AMENDMENTS TO THE DRAWINGS:

REMARKS:

FIG. 2
Prior Art

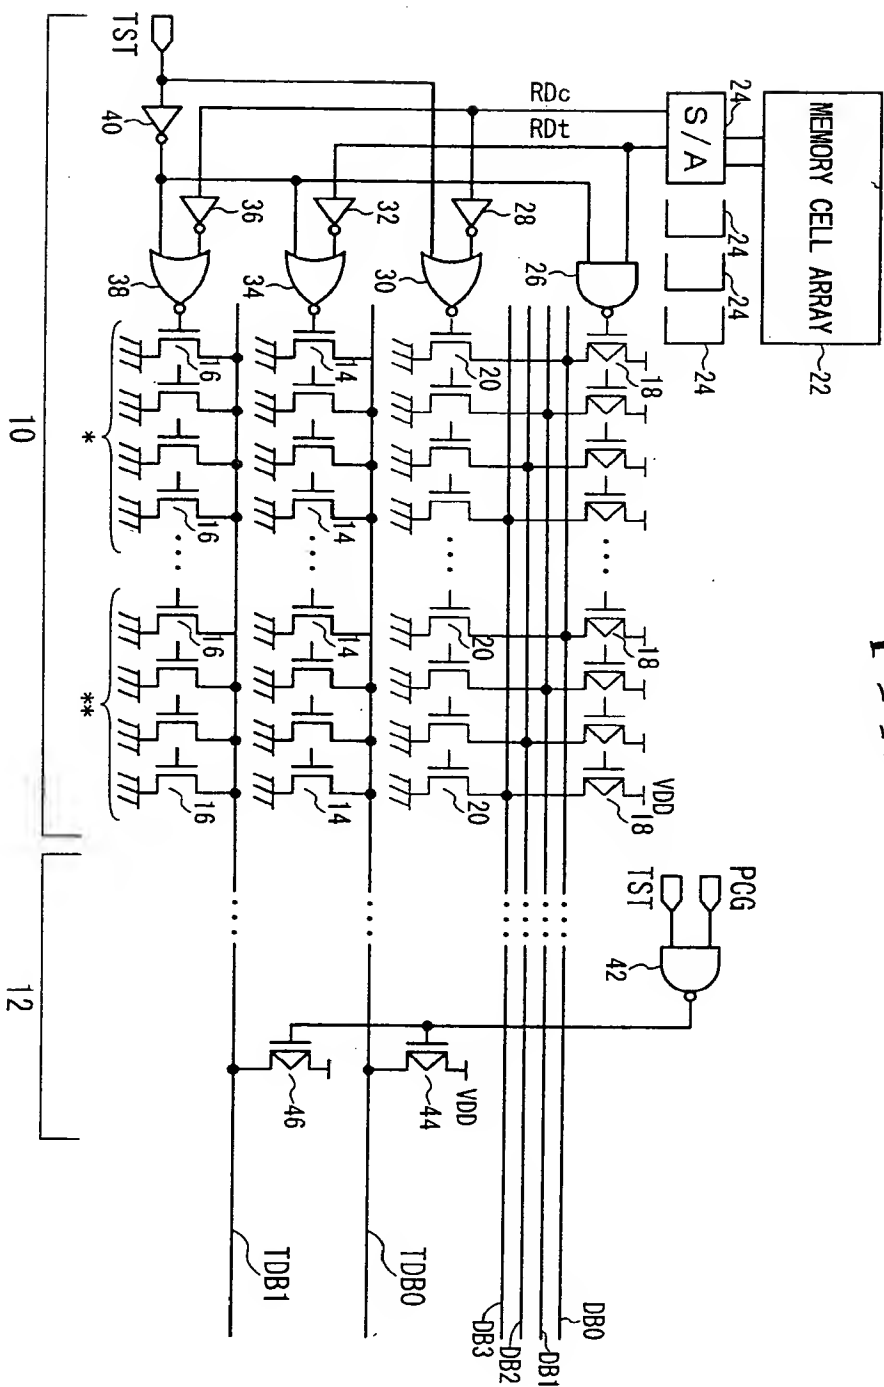
In the Office Action mailed July 5, 2005, the Examiner objected to the drawings. Specifically, the Examiner asserts that Figures 1A, 1B, and 2 fail to include a "Prior Art" legend. In accordance with the Examiner's suggestions, Applicants have amended Figures 1A, 1B, and 2 to include a "Prior Art" legend. Therefore, Applicants respectfully request that the Examiner withdraw the objection to the drawings.

The Examiner asserts that AAPA discloses or suggests each and every element of Applicants' independent claim 1. In particular, the Examiner states "according to [Figure 2 of AAPA], regardless of the operation mode, data bus lines DB0-DB3 still [are responsive] to signal RDt from the sense amplifier 24." Office Action, Page 5, Lines 2 and 3. Applicants understand that the Examiner is equating this alleged feature of AAPA with the claim limitation that "in the second operation mode, the first data line [is set] to a signal level responsive to one of the two signals," as set forth in Applicants' independent claim 1. Applicants respectfully disagree with the Examiner's characterization of AAPA.

For example, in Figure 2 of AAPA, the TST signal becomes HIGH in the test mode, which results in the output of the NAND gate 26 being fixed to HIGH, and the output of the NOR gate 30 being fixed to LOW. Therefore, **in the test mode, the data bus lines DB0-DB3 are not responsive to either the signal**

The attached sheets of drawings include changes to Figures 1A, 1B, and 2. These sheets replace the original sheets including Figures 1A, 1B, and 2. Specifically, and in accordance with the Examiner's suggestions, Applicants are amending Figures 1A, 1B, and 2 to include a "Prior Art" legend.

RDt or the signal RDc. Consequently, AAPA fails to disclose or suggest at least the feature that “in the second operation mode, the first data line [is set] to a signal level responsive to one of the two signals,” as set forth in Applicants’ independent claim 1. Therefore, Applicants respectfully request that the Examiner withdraw the anticipation rejection of independent claim 1 at least for this reason.
